K-14/D029

Re: Certification Submittal for Permanent Building Certificate of Occupancy for Silver Gardens Phase 2 [K-14 / D099]
100 Silver SW
Architect's Stamp Dated 11/30/11

Re: Silver Gardens Phase II, 100 Silver Ave SW,
Request for Permanent C.O. - Approved
Engineer's Stamp dated: 06-06-2011, (K-14/D099)
Certification dated: 11-29-11

Re: Silver Gardens Grading and Drainage Plan
Engineer's Stamp dated 9-17-08 (K14/D99)

ALT #2 PROPOSED CHANGE

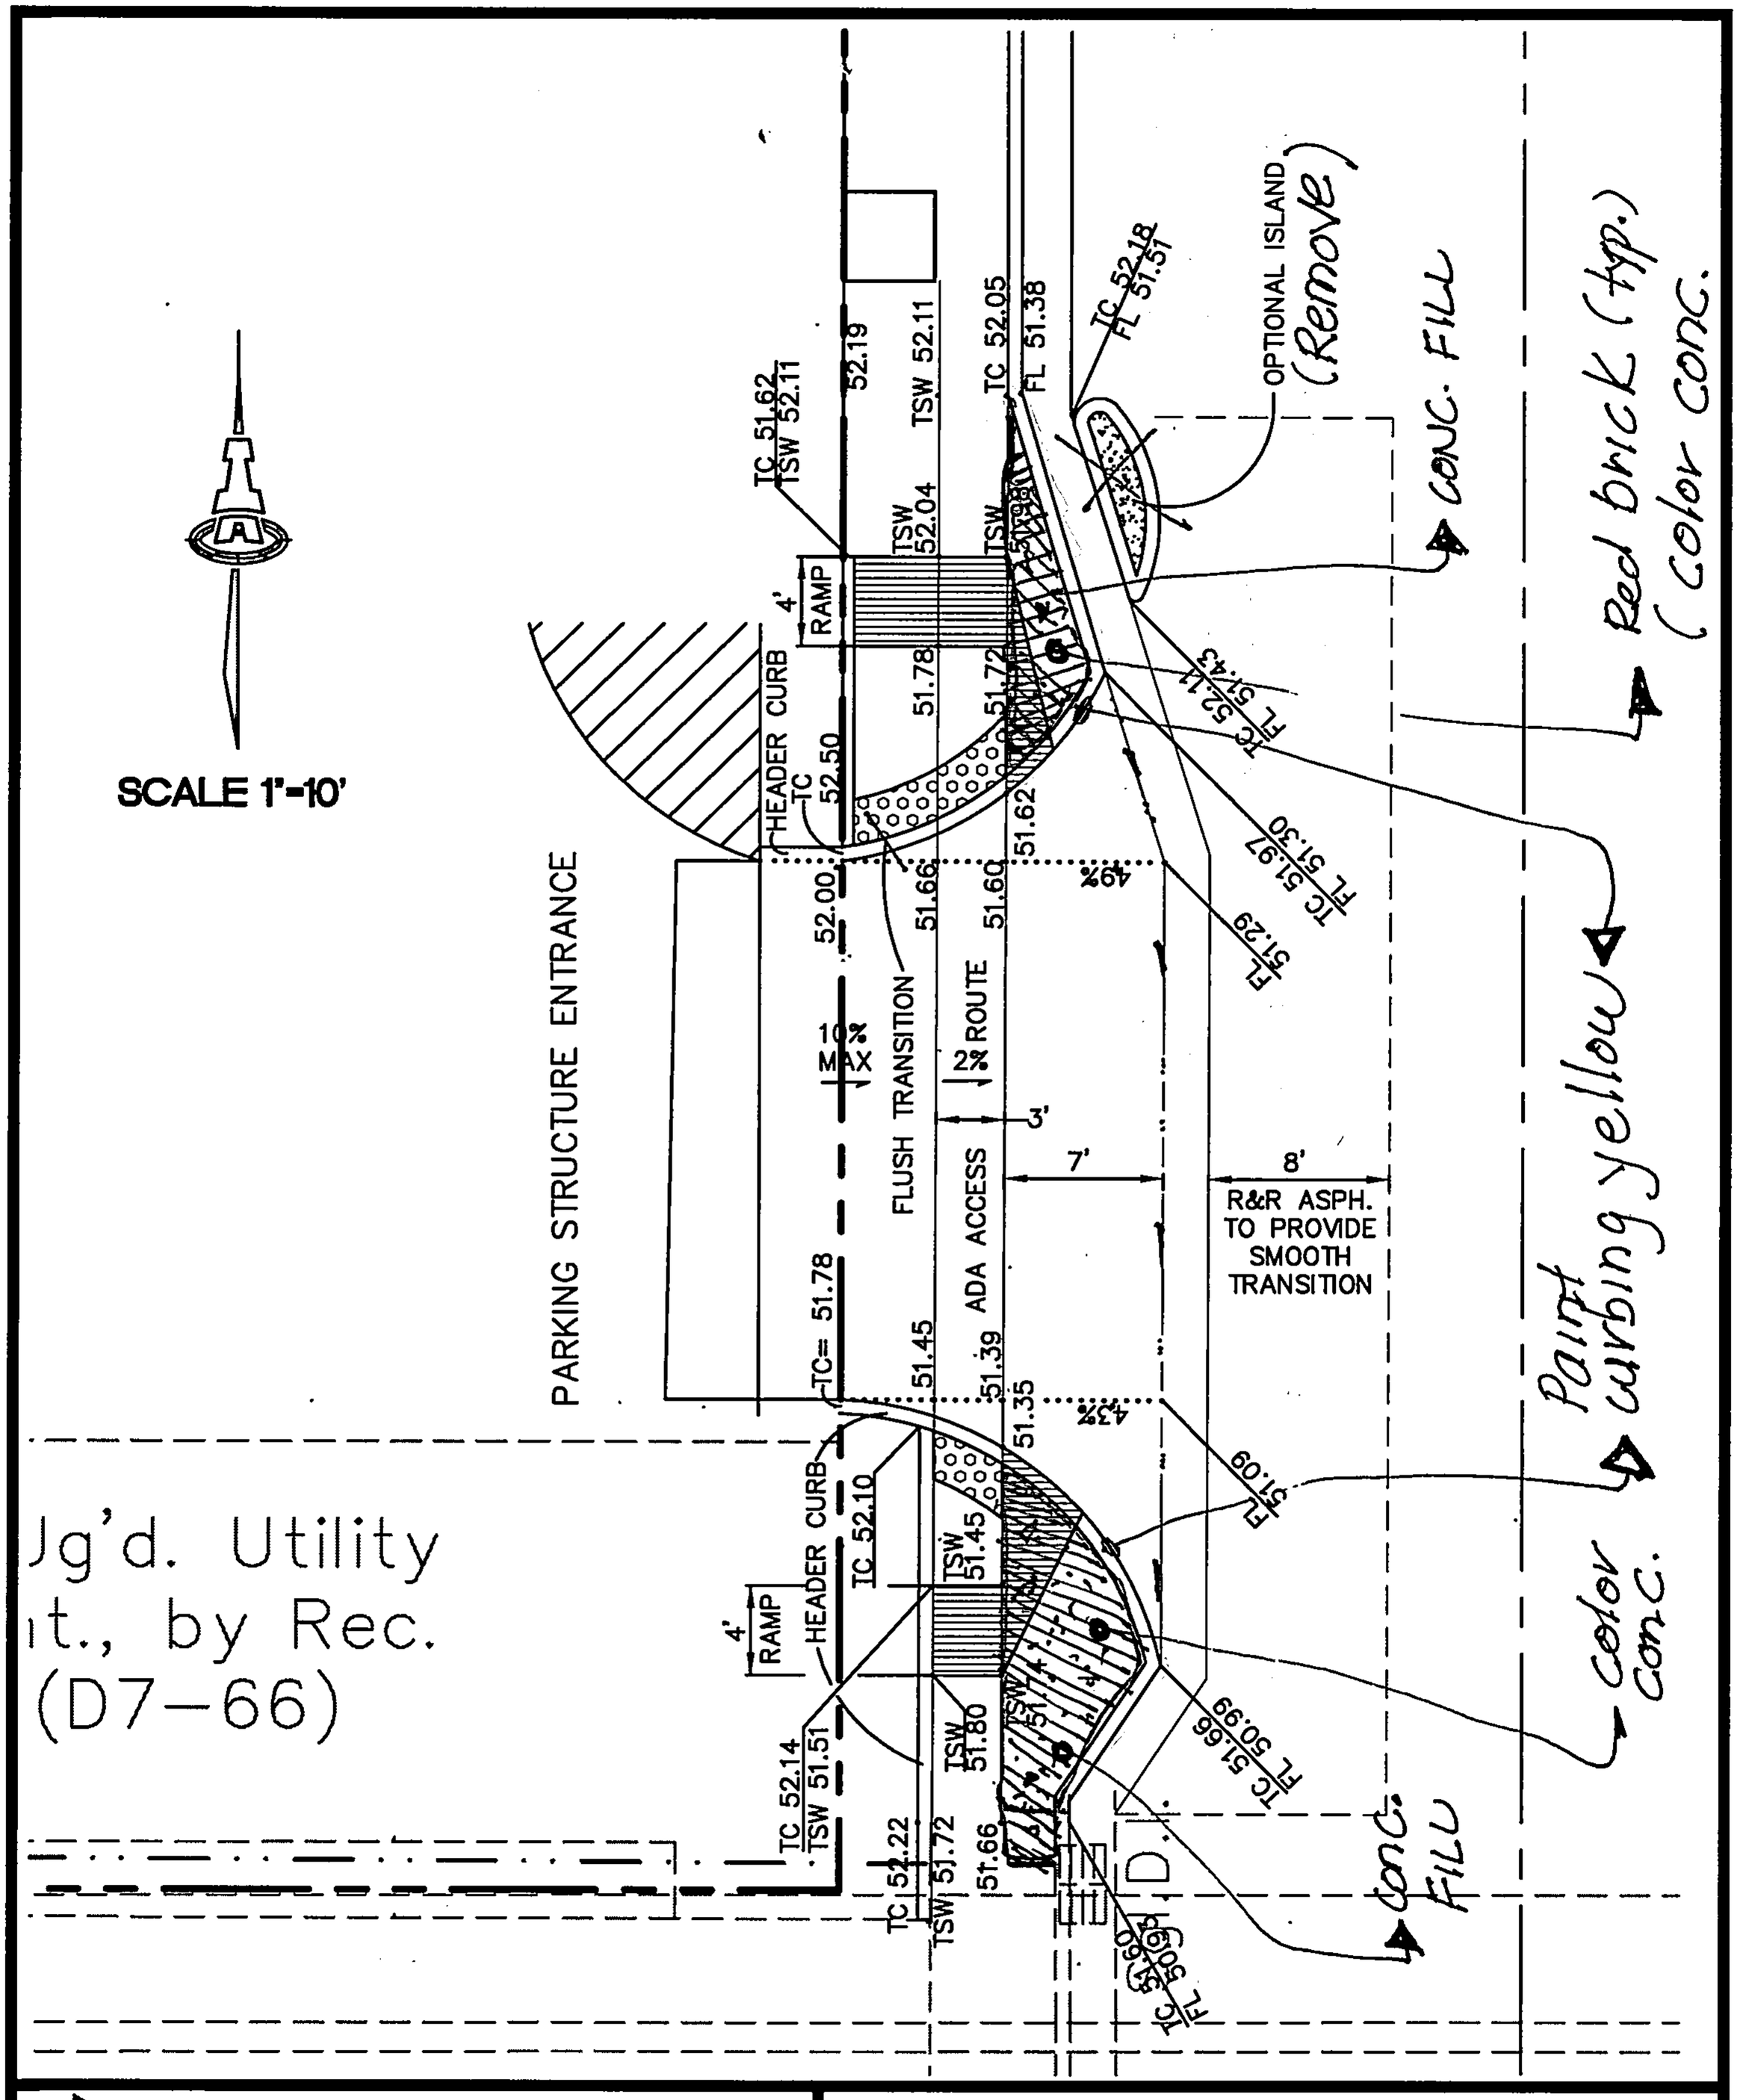
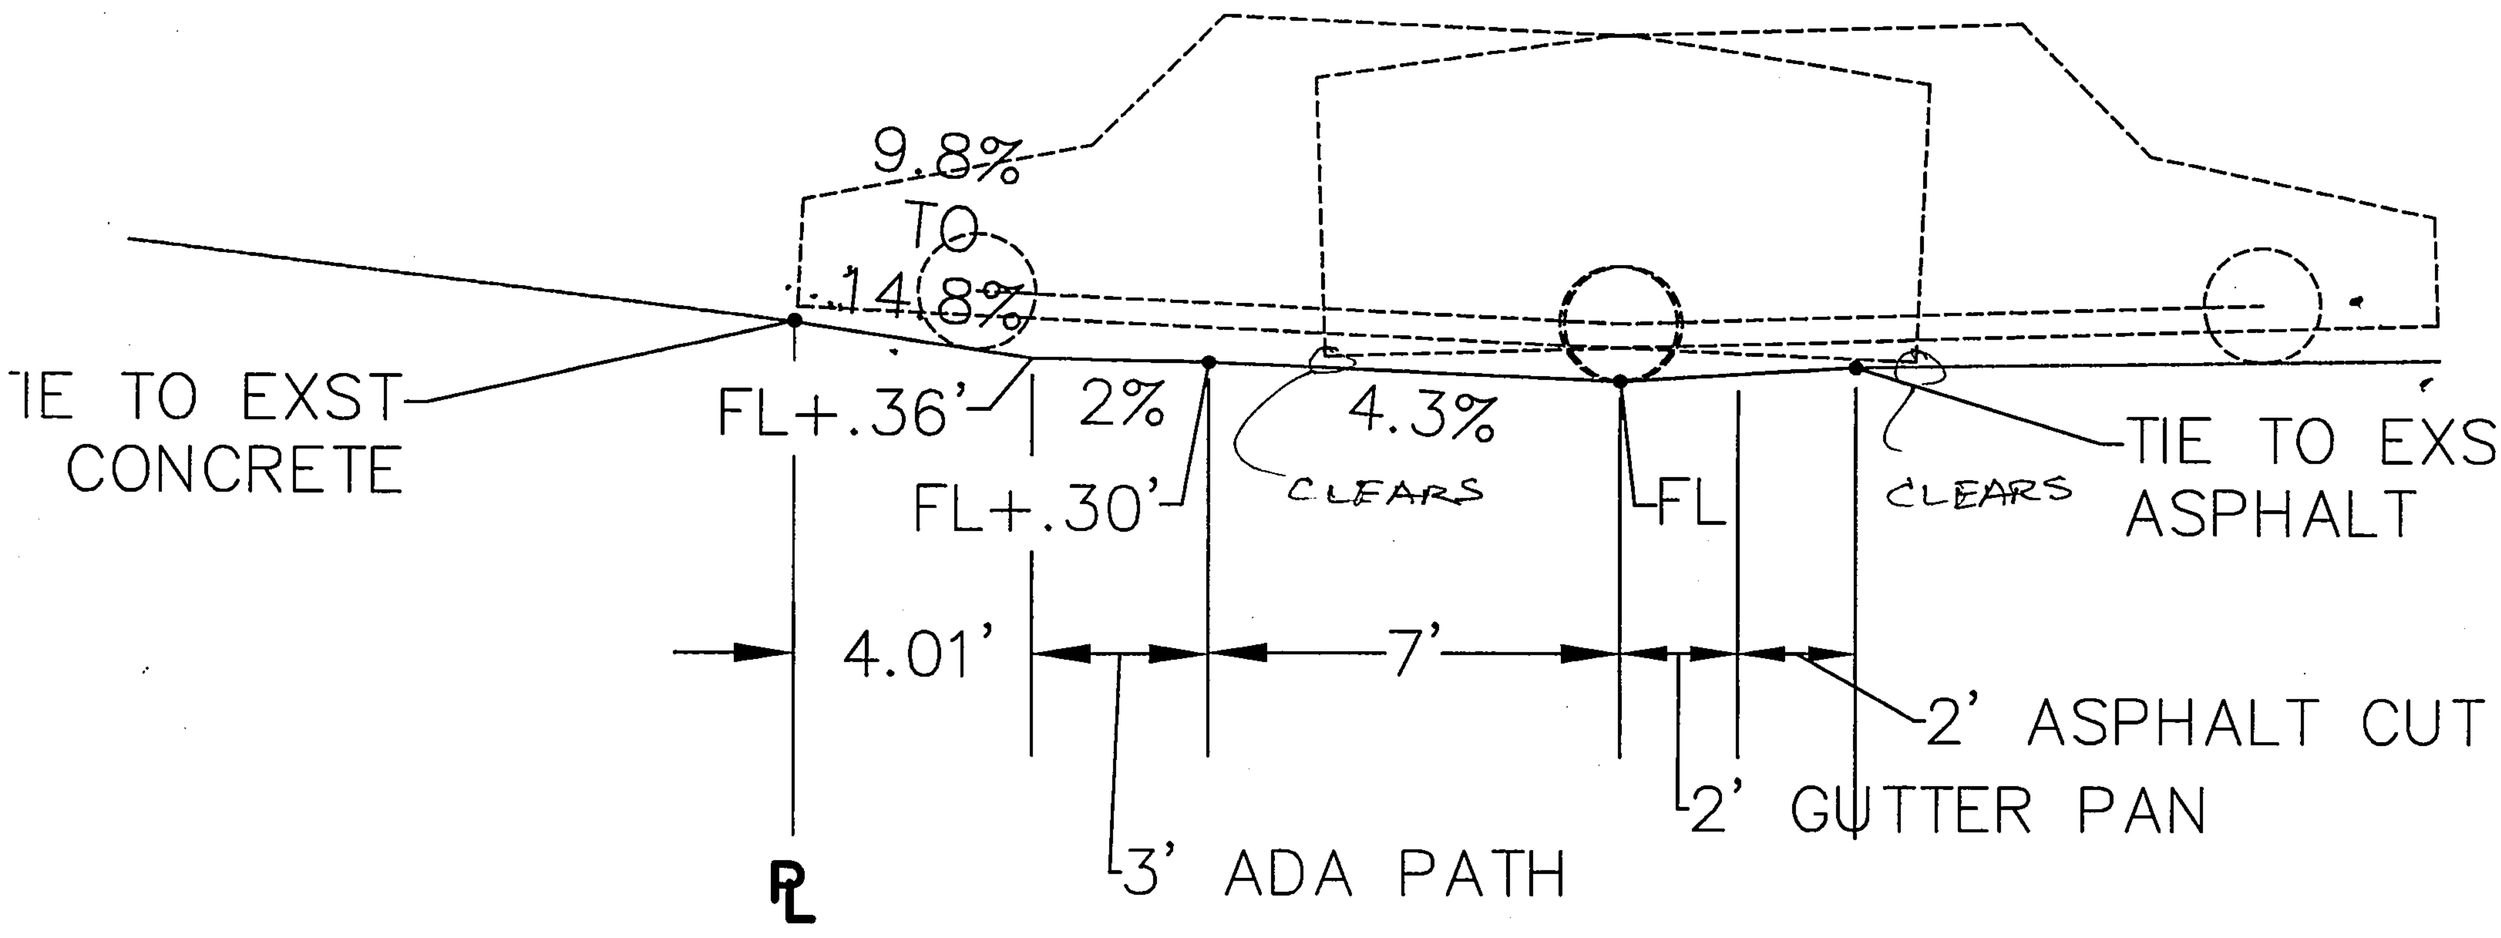
ADD'L 4' INTO ROAD
